# Access Compliance Report

## Public Rights-of-Way

Intersection ID: 26037	Main Street: FLOWERING_DOGWOOD_LN	Cross Street: STAPLETON_LN	Location: SW
ADA ID: 72A97BA54134	Ramp Type: Perp	Initial Pass/Fail: Fail	Overall Compliance: No
Severity Score: 21.25			
Codes/Mitigation Info/Possible Solution		Field Measurements/Component Compliance

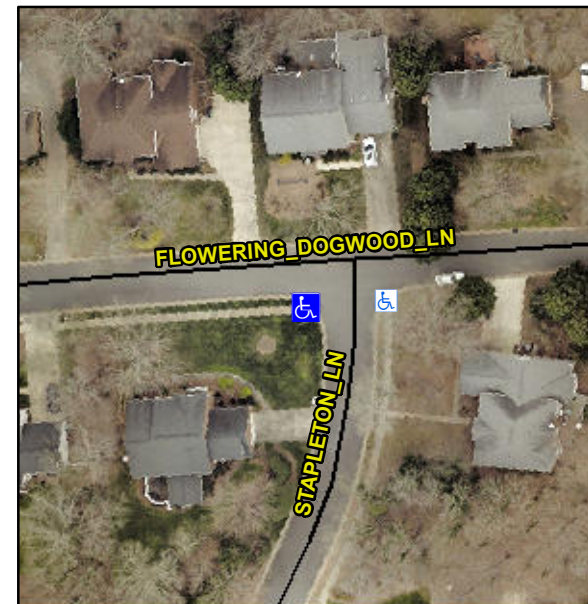
**Not Found, R304.5.1, R304.2.2**

Compliance	Description	Data	Compliance	Description	Data
N/A	Ramp Length (in)	59.0	No	Ramp Slope (%)	10.1
No	Ramp Width (in)	41.0	Yes	Ramp XSlope (%)	1.2
N/A	Flare Type LT	N/A	N/A	Flare Type RT	N/A
N/A	Flare Slope LT (%)	N/A	N/A	Flare Slope RT (%)	N/A
N/A	Flare Traversable LT?	N/A	N/A	Flare Traversable RT?	N/A
N/A	Landing Length (in)	N/A	N/A	DWS Provided?	N/A
N/A	Landing Width (in)	N/A	N/A	DWS Contrast?	N/A
N/A	Landing Slope (%)	N/A	N/A	DWS Length (in)	N/A
N/A	Landing X Slope (%)	N/A	N/A	DWS Full Width?	N/A
N/A	Landing Curb? (Y/N)	N/A	N/A	DWS Offset (in)	N/A
N/A	Shared Landing?	N/A			
N/A	Gutter Ponding?	N/A	N/A	Gutter Slope (%)	N/A
N/A	Gutter Lip Ht (in)	N/A	N/A	Gutter X Slope (%)	N/A
N/A	Painted X Walk1?	No	N/A	Painted X Walk2?	N/A
	X Walk 1 Direction	To E		X Walk 2 Direction	N/A
N/A	X Walk 1 Width (in)	N/A	N/A	X Walk 2 Width (in)	N/A
	X Walk 1 Slope (%)	1.9		X Walk 2 Slope (%)	N/A
	X Walk 1 X Slope (%)	4.6		X Walk 2 X Slope (%)	N/A

**Remove & Replace Entire Ramp.**
